REMARKS

Revisions to the Application

Annotated Marked-up drawings

FIG.6A

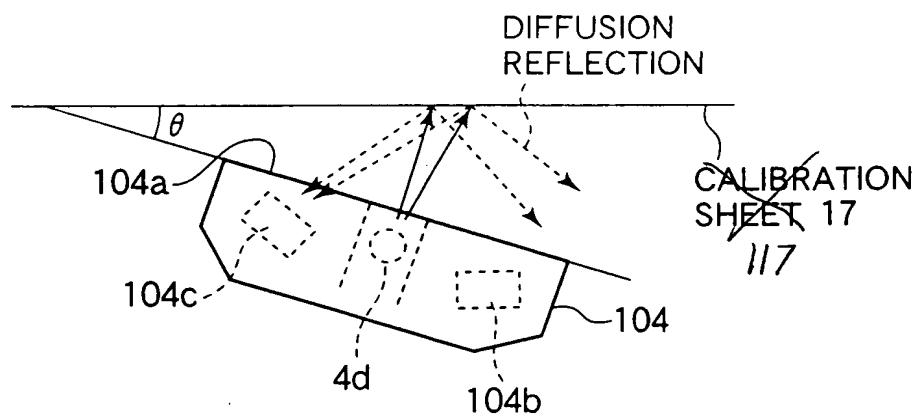
The present application discloses several embodiments of an improved electrostatic printing apparatus. With reference to Figure 6A of the application’s drawings, an LED 4d in a density sensor 104 shines light on a reference or calibration sheet 117, which reflect the light back to the density sensor 104. The current flowing through the LED 4d is changed so as to detect sensor output corresponding to different current values. When covering section 117 is at a closed position (see Figure 4), an adjustment section adjusts the output of the density sensor 104 with respect to a surface of the covering section 117.
